Punjab Road Sector Project – Phase II

Name of work: Construction of High Level Bridge over Satluj River (Including approaches on both sides) crossing Makhu to Sultanpur Lodhi Road near Gidarpindi (Balance Work).

Clarifications to the queries in the pre-bid meeting held on 09.10.2009 at 11.00 A.M. in the Committee Room of Punjab Infrastructure Development Board, SCO 89-90, Sector 34-A, Chandigarh. These clarifications of pre-bid meeting will form the part of DNIT. The list of agencies who attended the pre bid meeting is enclosed:

DETAILS OF TOLL PLAZA
N.T.S

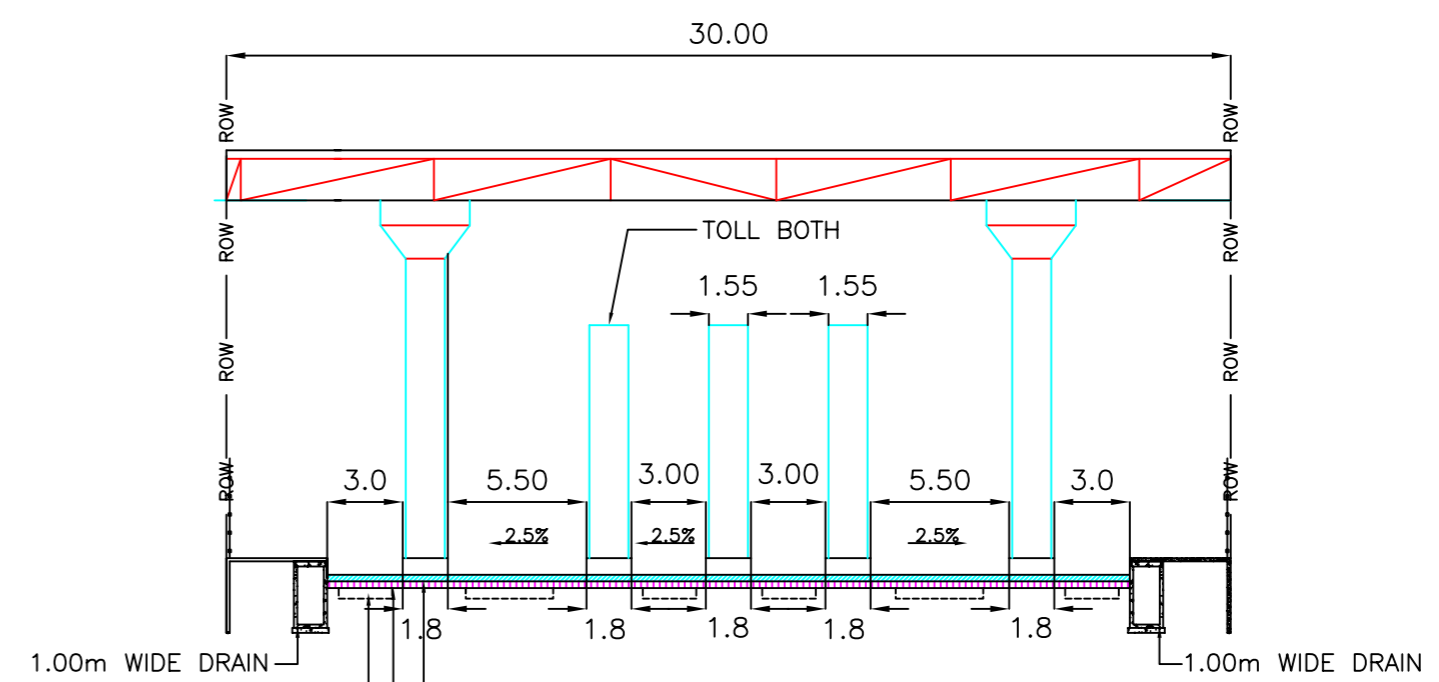
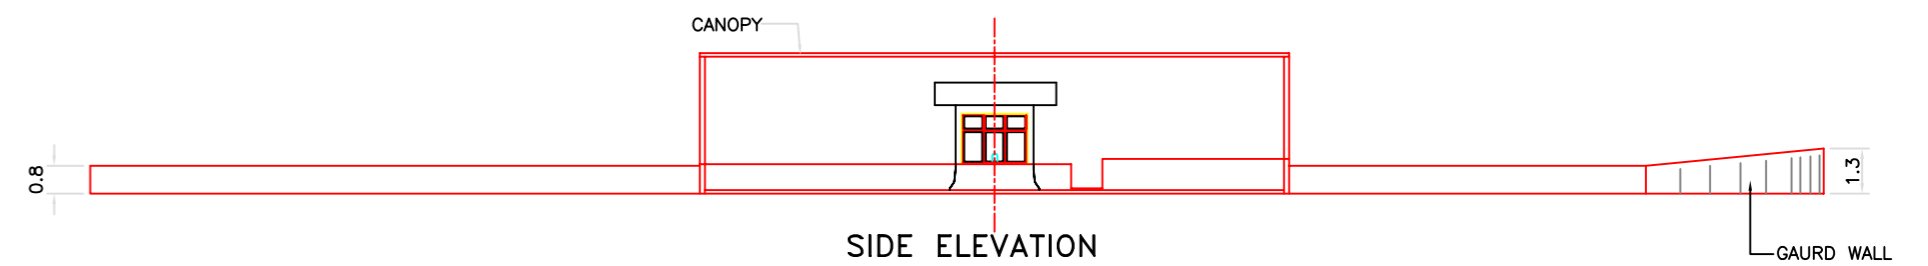
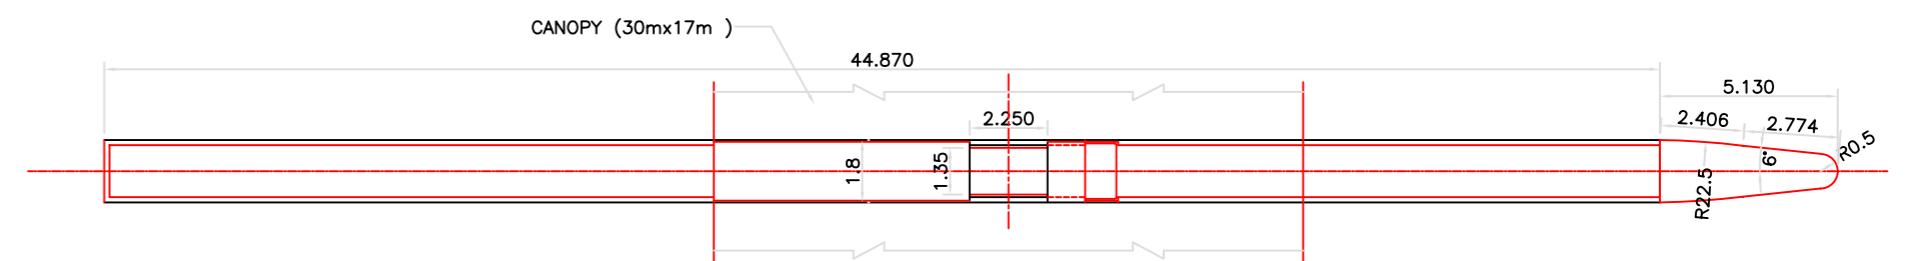
24.				Toll Plaza Proposed location of toll plaza, chainage, L Section and Cross Section of road shall be provided	As per DNIT and revised drawing uploaded
